**AGENDA PACKET**

**MARCH 19, 2019 MEETING**

**AGENDA**

**Tuesday, March 19, 2019**

**WACCABUC COUNTRY CLUB**  
90 MEAD STREET  
LEWISBORO, NY 10597  
**SITE UTILITY  
DRAINAGE, SOIL & EROSION  
CONTROL PLAN**

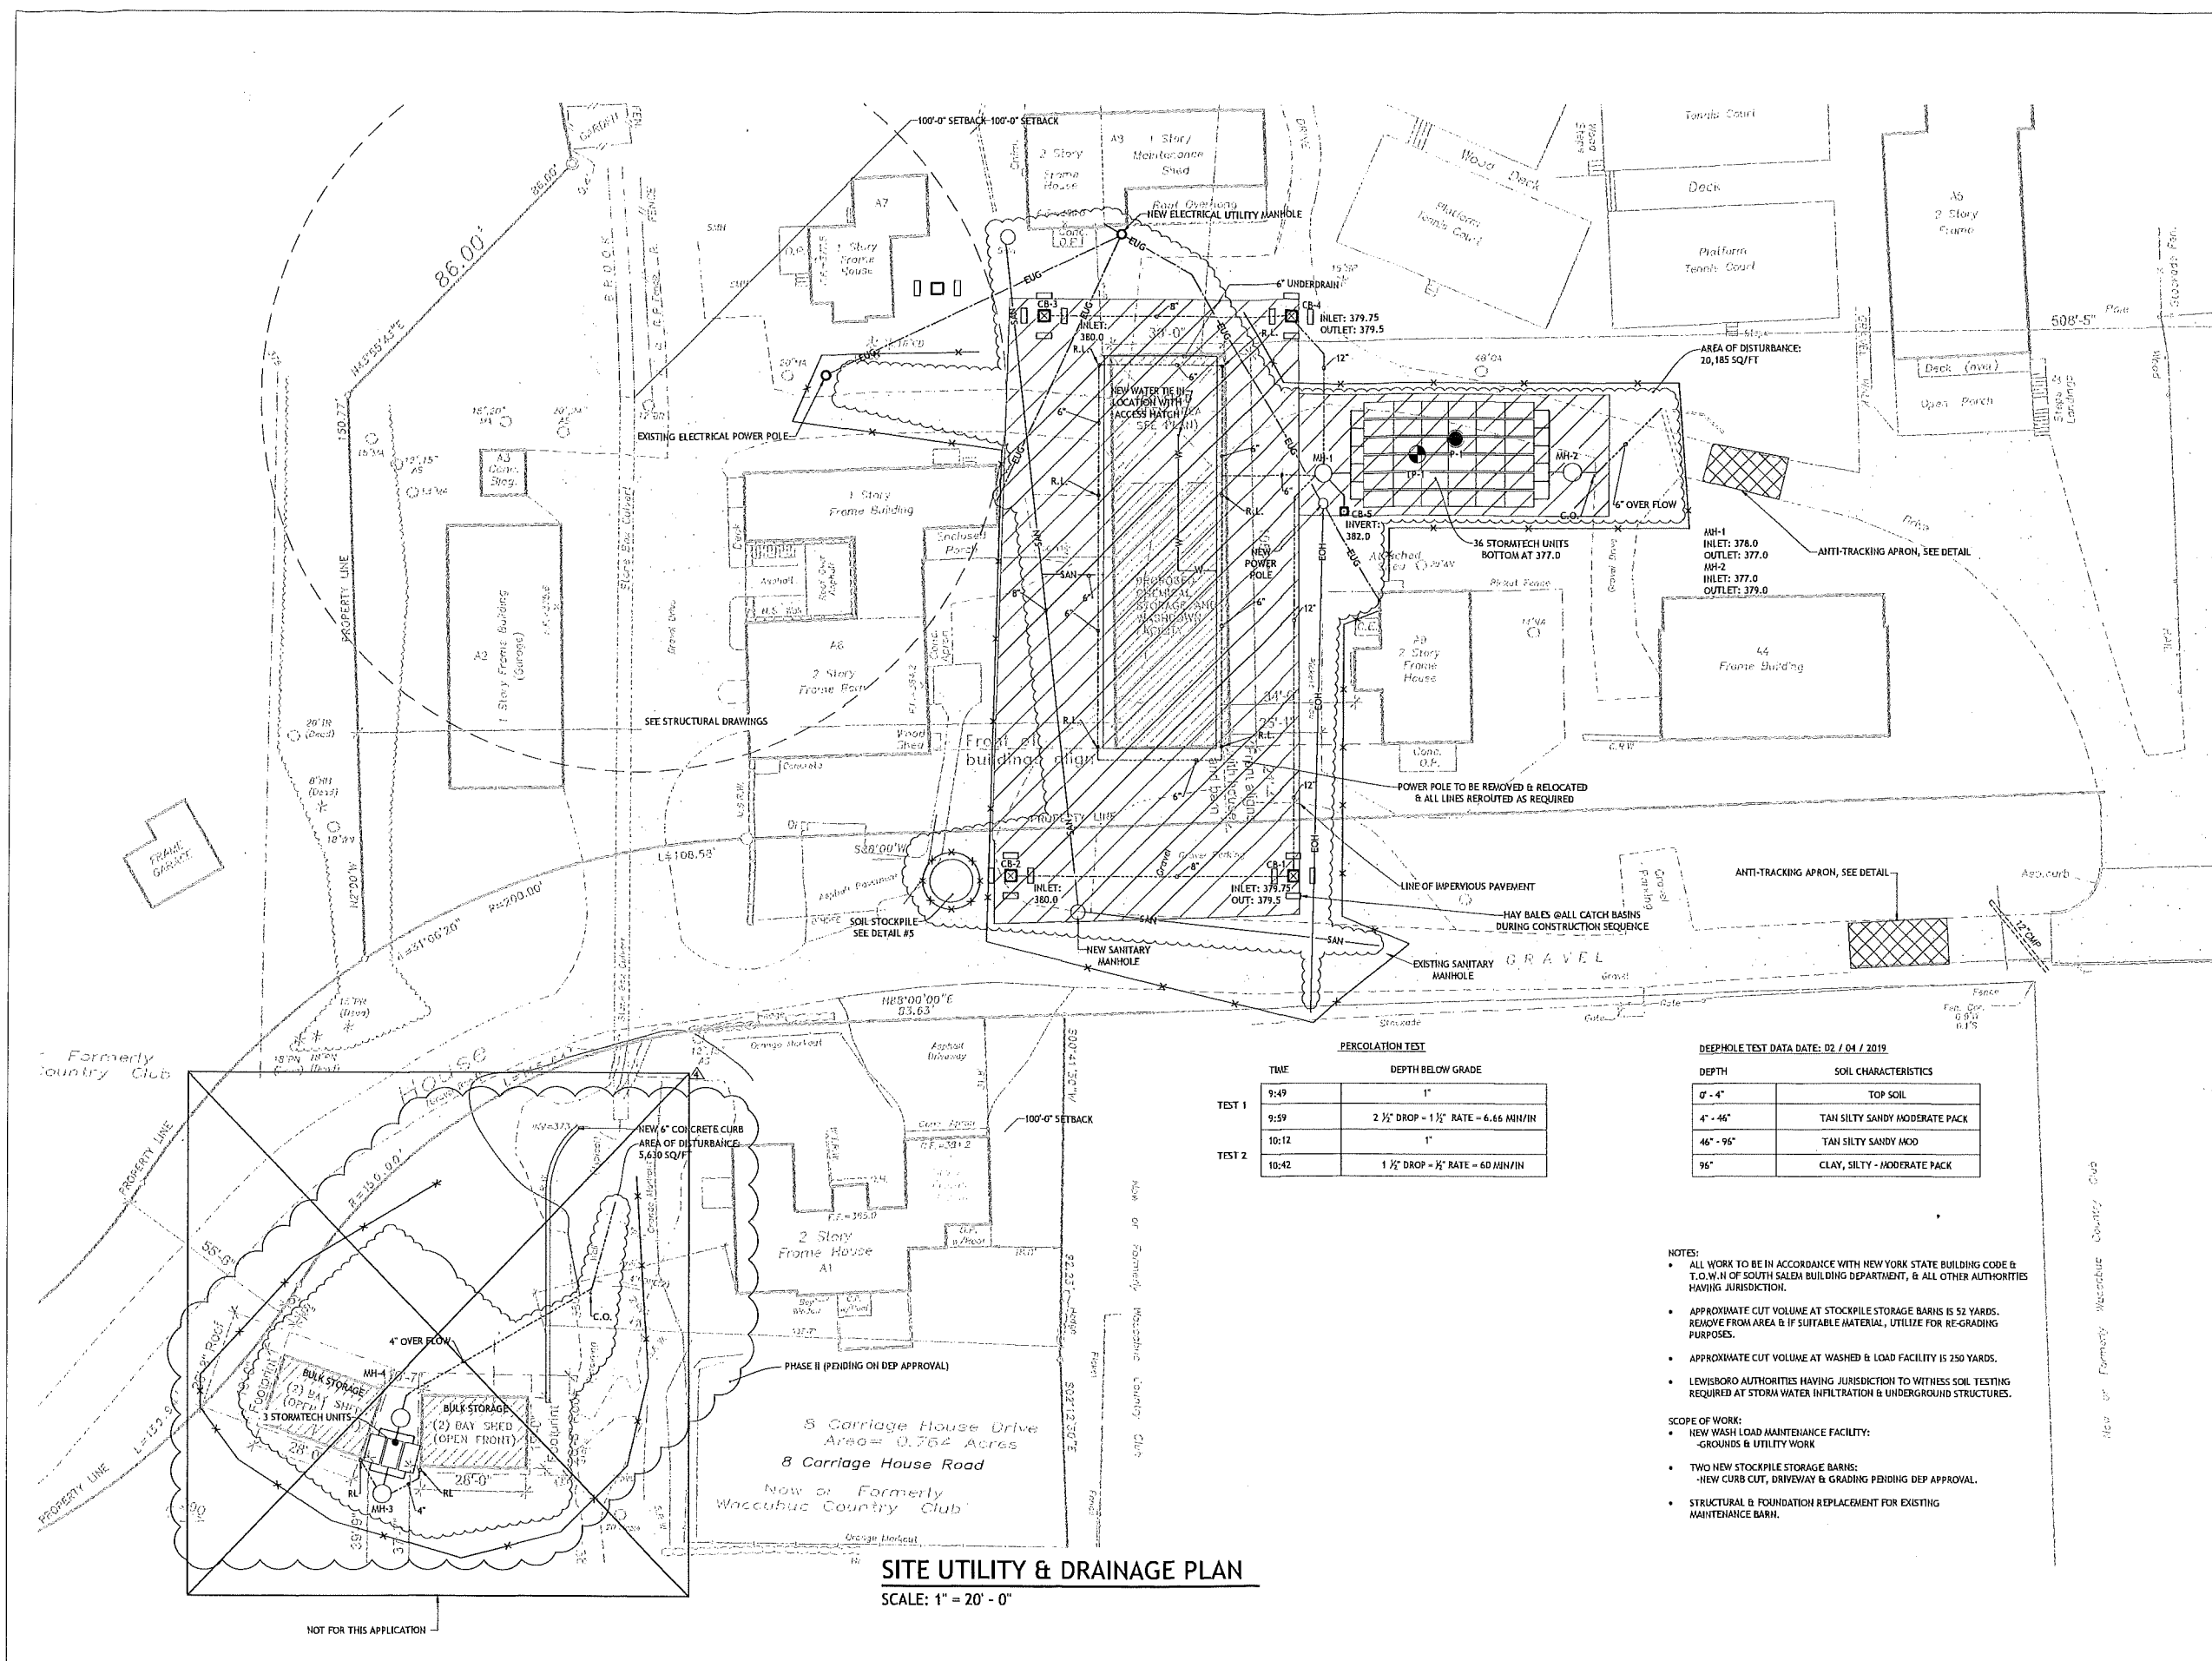
1. Full-size, signed and sealed versions of the latest site plans shall be submitted for review.
2. As shown on the reduce-sized plans provided in the Stormwater Pollution Prevention Plan (SWPPP), the Bulk Storage sheds are no longer proposed. These improvements shall be removed from all future submissions.

8. As previously requested, the plan shall clearly illustrate limits of the existing and proposed gravel and paved drives.
9. As previously requested, the drives and access areas should be dimensioned to demonstrate adequate vehicle circulation and maneuvering.

10. As previously requested, provide all rim and invert elevations, pipe material and slope, as appropriate, for all storm and sewer improvements.
11. As previously requested, include a north arrow on all site plans.

13. The applicant should clarify if the dual-fuel tank and containment pad is still being proposed. If so, illustrate it on the plan and provide construction details.

14. Provide construction details for all improvements, including, but not limited to, drainage structures and facilities, sewer service connection, pavement, pipe trench, pipe bollards, etc.

15. As previously requested, the pipe bollards shown on the building elevations should be located on the site plan.
16. As previously requested, the applicant should be prepared to discuss the chemical handling process (delivery, storage, sludge handling and waste removal).

17. As previously requested, any proposed site lighting (building or pole mounted) shall be illustrated and detailed on the plan.
18. The location of the existing and proposed water services shall be clarified. It appears the infiltration system is located over the existing water service. The water service shall be rerouted to avoid all existing utilities and maintain the required setbacks to the sewer system.
